MEMORANDUM FOR: R. W. Reid, Chief, Operating Reactors Branch #4, DOR  
FROM: G. Lainas, Chief, Plant Systems Branch, DOR  
SUBJECT: OCONEE NUCLEAR STATION UNITS 1, 2 AND 3: EVALUATION OF  
THE ELECTRICAL INSTRUMENTATION AND CONTROL (EI&C) ASPECTS  
OF THE PROPOSED MODIFICATION OF HIGH PRESSURE INJECTION  
SYSTEM (TACS 10111, 10112 & 10113)

SAFETY EVALUATION OF THE ELECTRICAL,  
INSTRUMENTATION AND CONTROL ASPECTS  
OF THE PROPOSED MODIFICATION OF HIGH  
PRESSURE INJECTION SYSTEMS OF OCONEE  
NUCLEAR PLANT, UNITS 1, 2 AND 3

# COAL NUCLEAR STATION PROPOSED MODIFICATION OF HPI SYSTEM

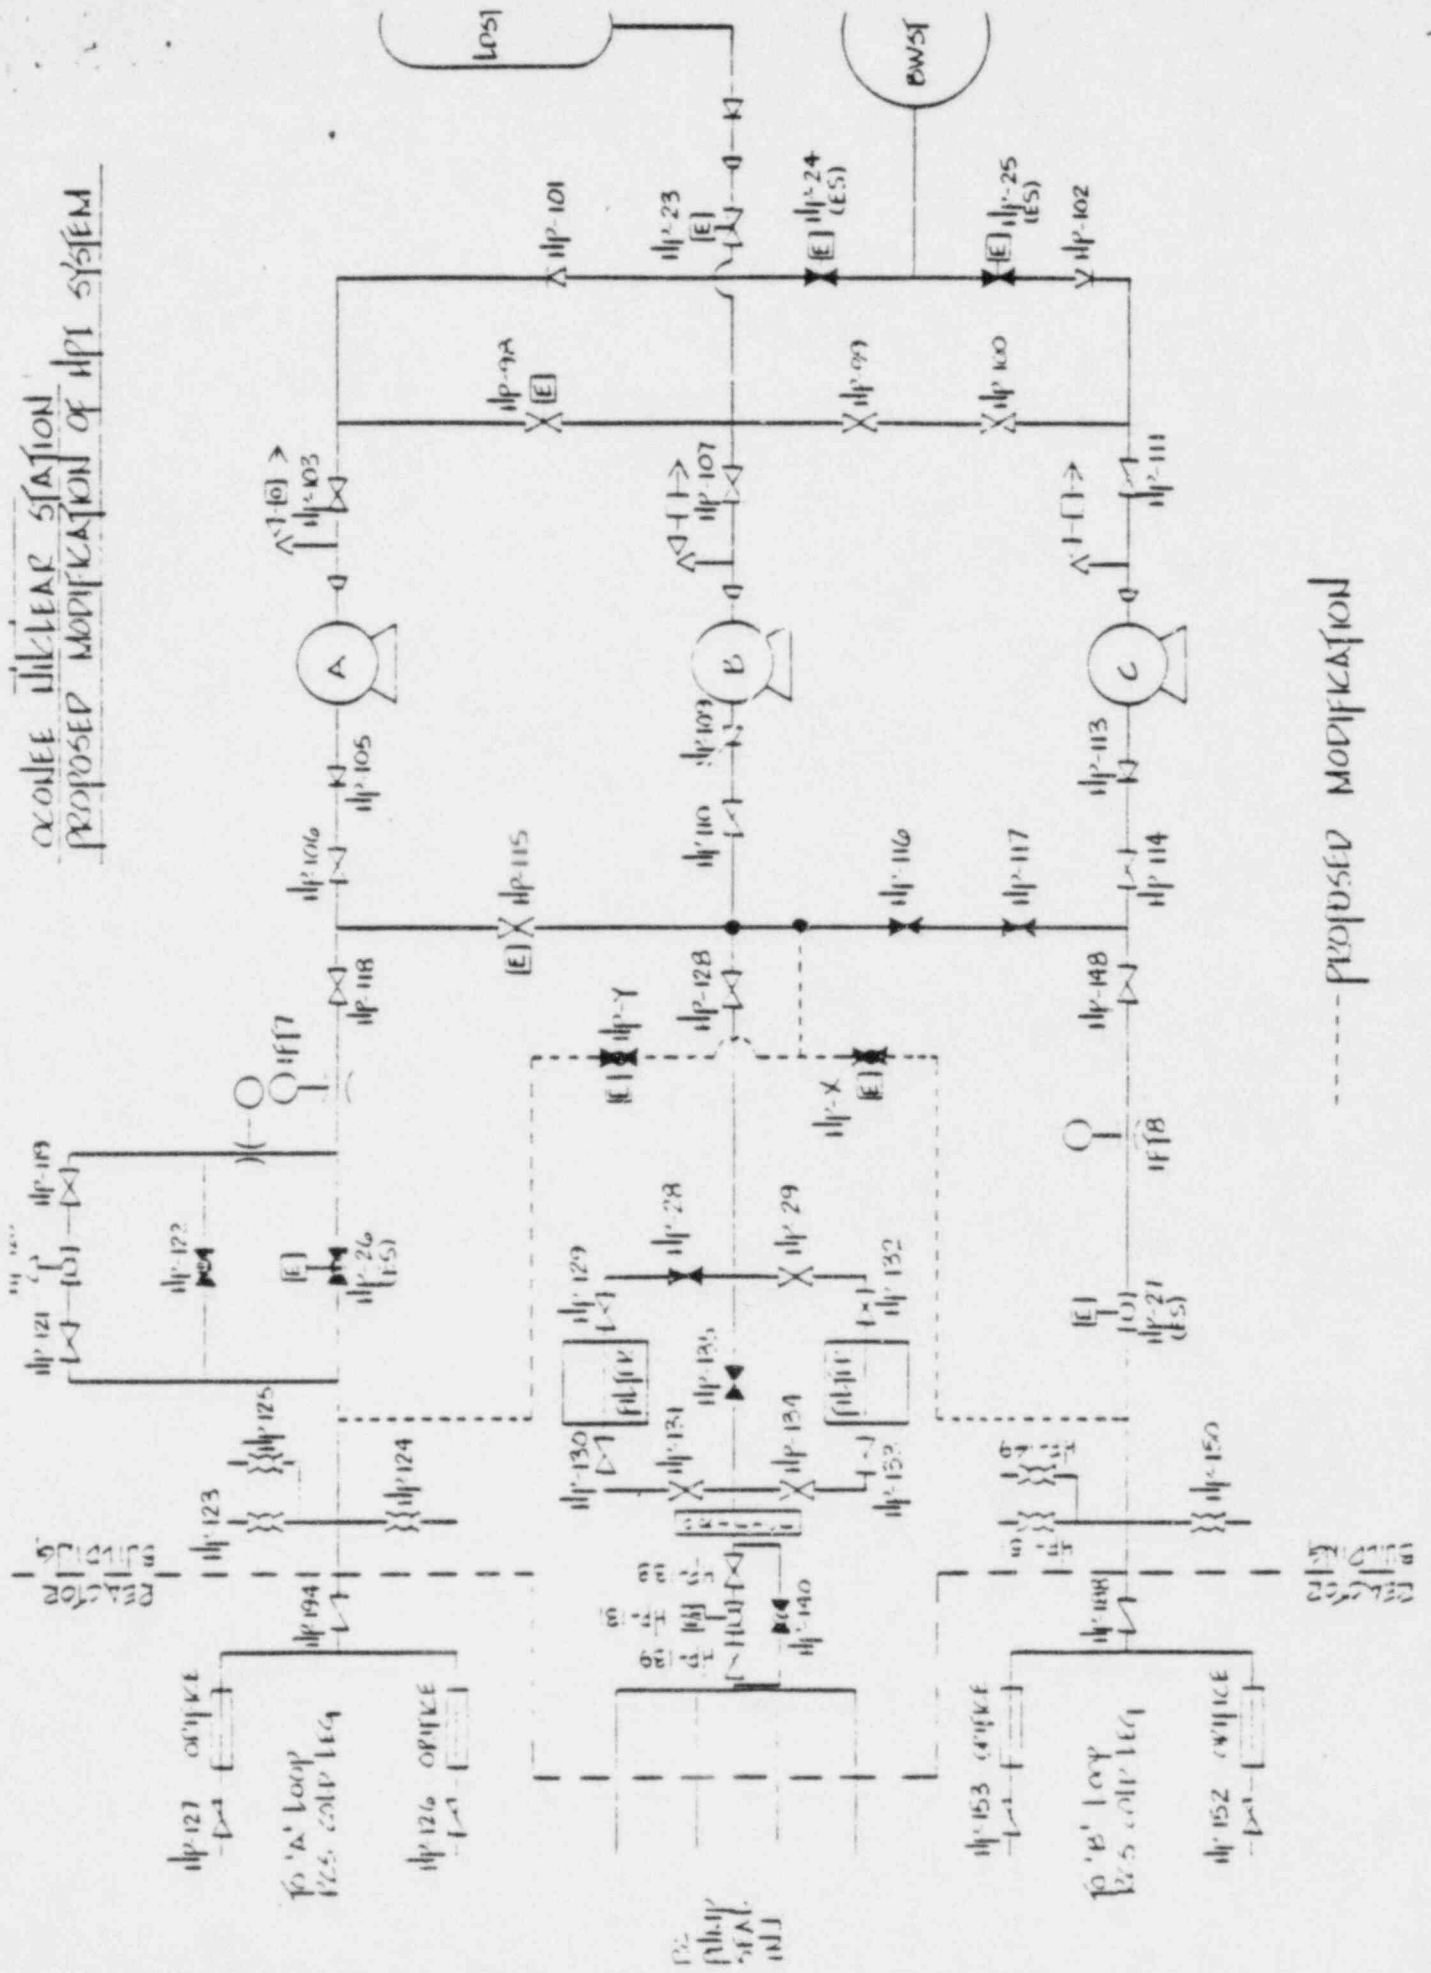
The proposed modification consists of installing a cross-connect line between the A and C HPI discharge lines downstream from the ES valves (HP-26 or HP-27) and another tie line connecting this cross-connect line and the HPI pumps common discharge header (see Figure 1). Remote-manually-controlled, electrically operated isolation valves HPI-X and HPI-Y, capable of being operated from the control room, will be provided. The motor operators of

isolation valves HPI-X and HPI-Y will be supplied power from the Blue Bus 600V and 208V MCC (depending upon the rating of the motor operator) which is supplied by the 4160V Engineered Safeguards (ESF) Blue Bus XTE (where X = 1, 2 or 3 for Oconee Unit 1, 2 or 3) (Reference FSAR Figures 8-2, 8-3, 8-4). The HPI-A flow train elements (valves HP-24 and HP-26, and HPI pump A) are supplied power from the ESF Gray Bus and the HPI-B flow train element (valves HP-25 and HP-27, and HPI pump C) are supplied by the ESF Yellow Bus. The three redundant ESF buses (Blue, Grey and Yellow) are each in turn supplied power from the two redundant main 4160V feeder buses. With this configuration the operators of isolation valves HPI-X and HPI-Y are seen to be powered by a source of power supply independent of that supplying power to the HPI-A and HPI-B flow trains.

The proposed modification requires an operator to perform the action of positioning the control switches of isolation valves HPI-X and HPI-Y to the open position, in the event of a small break LOCA and the loss of one of the existing (HPI-A or HPI-B) flow trains. The operator will take this action when no flow occurs (as indicated by control room Class IE flow indicator) in one of the HPI flow trains during a LOCA. The licensee has stated that the analysis provided and the modifications proposed are consistent with the staff positions regarding allowable operator actions for which credit may be taken following a small break LOCA. (This has been reviewed by the Reactor Safety Branch.)

By supplying power to the motor operators of the proposed isolation valves from a source of power supply independent of that supplying power to the HPI-A and HPI-B trains, the proposed modifications will assure that the HPI trains (two pumps and the two associated flow paths) will be available during design conditions involving worst case single failure.

1. The proposed design modification to the High Pressure Injection system will assure that for all postulated single failure conditions the HPI system will be capable of supplying HPI flow by two HPI pumps through two injection paths.
2. The proposed modification will not affect the performance of other systems important to safety.
3. The proposed modification requires an operator to open the electrically operated controlled valves from the control room in the event of a small break LOCA and the failure of one of the HPI flow trains.
4. The material and equipment required to implement the proposed modification will be designed, manufactured, qualified and tested to the applicable standards and codes that apply to the ECCS system.

Accordingly, we conclude that the proposed design modification is acceptable.
